# Consultation

## **NGT's Methane emissions reduction and monitoring projects: Net Zero Pre-Construction Work and Small Projects Re-opener (NZASP)**

Publication date:	4.10.2023
Response deadline:	8.11.2023 (5 weeks)
Contact:	Keren Maschler
Team:	Price Control Operations – Heavy scrutiny projects
Telephone:	020 7901 7000
Email:	<a href="mailto:RIIOElectricityTransmission@ofgem.gov.uk">RIIOElectricityTransmission@ofgem.gov.uk</a>

**Figure 1: NGT 2021 calendar year methane emission sources and performance**

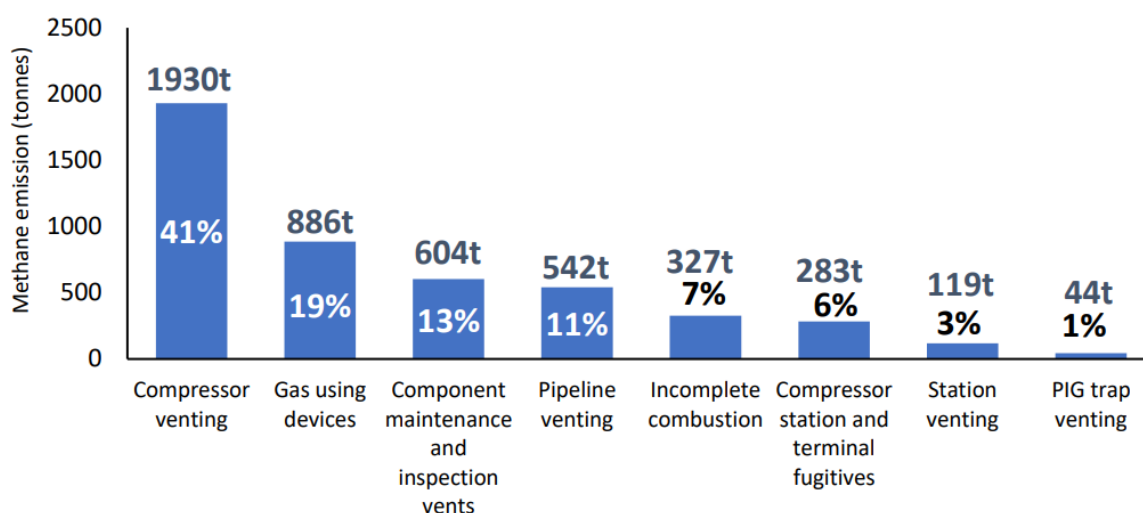
- 2.3 As part of RIIO-2 GD&T FDs<sup>8</sup>, Ofgem approved funding for a pair of such modern pipeline recompression machines, which are expected to capture 66% of the emissions in the pipeline venting category displayed in figure 1. NGT suggest investing in a second pair, which they expect will allow additional 24% of the gas in this category to be saved. The total expected reduction in emission of 90% equates to 490 tonne methane per Annum<sup>9</sup>.

- 2.10 NGT plans to have one additional pressure pipeline recompression set in operational service on planned pipeline depressurisation on the NTS.
- 2.11 NGT proposes that successful criteria should be that having no planned pipeline vents in the next PC and beyond, and greater than 90% reduction of emissions in this category of pipeline recompression (see figure 1).

**Figure 2: Spider diagram of CMT methane reduction options and their scoring following BAT assessment during CH4RGE NIA project**

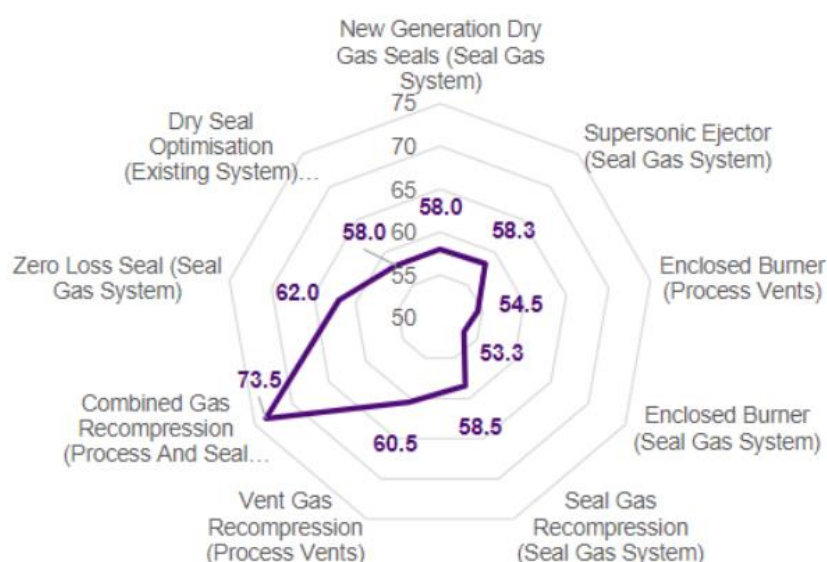
3.6 Figure 2 below shows the result of the option assessment using a spider diagram.

3.7 Following these investigations, NGT is seeking funding for the design, purchase and trial of methane emission reduction from CMT which utilises combined gas recompression (scored 73.5) and zero loss compressor seal (scored 62).

- 3.18 We are of the view that the proposed technologies that were scored highest in the innovation work should be trialled to allow reduction of methane emissions: combined gas recompression and zero loss seal. These trials should allow NGT to understand the impact on emissions, the reliability of the solution and the challenges of integrating those solutions.

**Figure 3: weekly mass emission rate estimates from MoRFE field campaign**

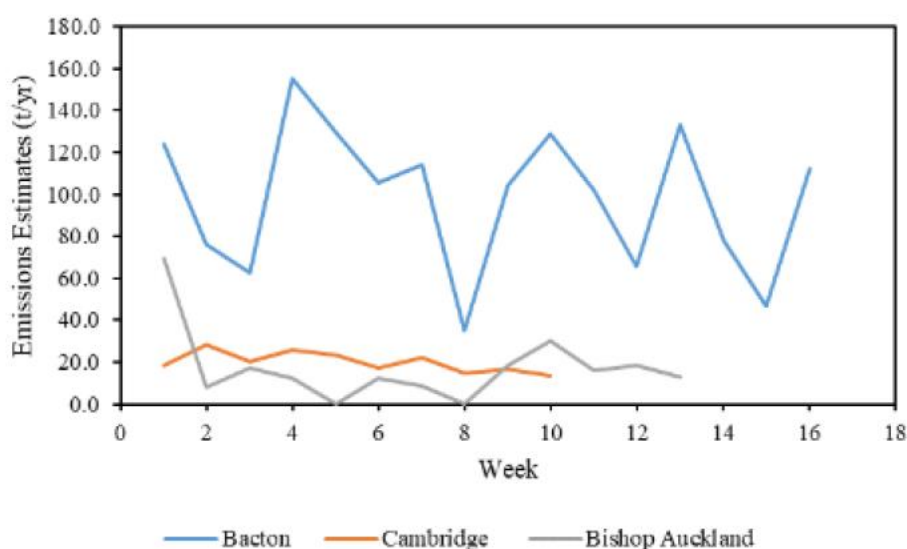
4.32 Figure 3 below shows weekly mass emission rate estimates from MoRFE field campaign.

- 4.41 This investment does not reduce methane emissions or identify the exact location of leaks to enable repair. Reading the [close out report](#) from the MoRFE it is clear that continuous monitoring is not accurate for fugitive leaks and mainly identifies vents from activities that are normally an unavoidable part of operating the system. As the report itself stated: "*The (detection system) itself cannot replace traditional walk over leak detection and repair surveys as it does not identify the individual leaking asset or component but can be used to identifying potential source areas which should improve speed of leak detection*".
